PHAP25-00045

Date: December 4, 2025
Application Type: Certificate of Appropriateness
Property Owner: Lydia Cordova
Representative: Lydia Cordova
Legal Description: 1 Radford Terrace S 35 Ft of 14 (3500.00 SQ FT), City of El Paso, El Paso County, Texas
Historic District: Austin Terrace
Location: 2147 King James Place
Representative District: #2
Existing Zoning: R-4/H (Residential/Historic)
Year Built: 1995
Historic Status: Non-Contributing
Request: Certificate of Appropriateness for the placement of a metal structure in driveway after-the-fact
Application Filed: 11/20/2025
45 Day Expiration: 1/4/2026

ITEM #2

ELEVATIONS

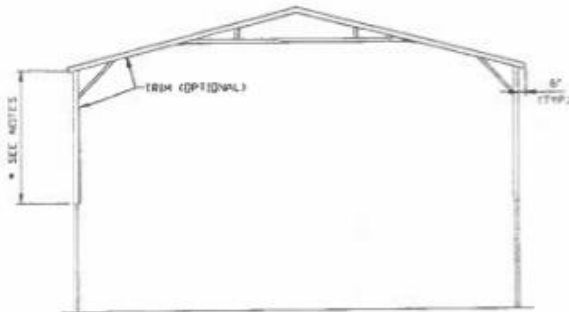
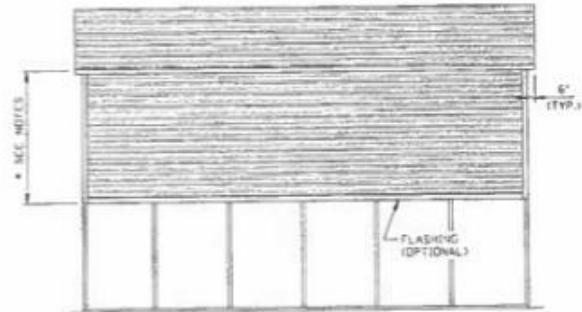
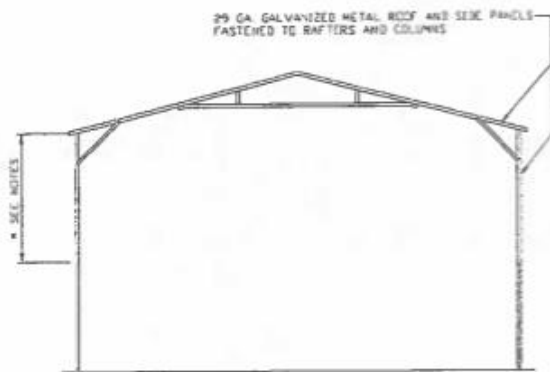
The Historic Preservation Office recommends APPROVAL WITH MODIFICATIONS of the proposed scope of work based on the following recommendations:

The modification is that the metal structure be relocated to the back of the property; that the artificial turf be removed; that the violations be corrected in thirty (30) days; and that no new permits be approved until the property is in compliance.
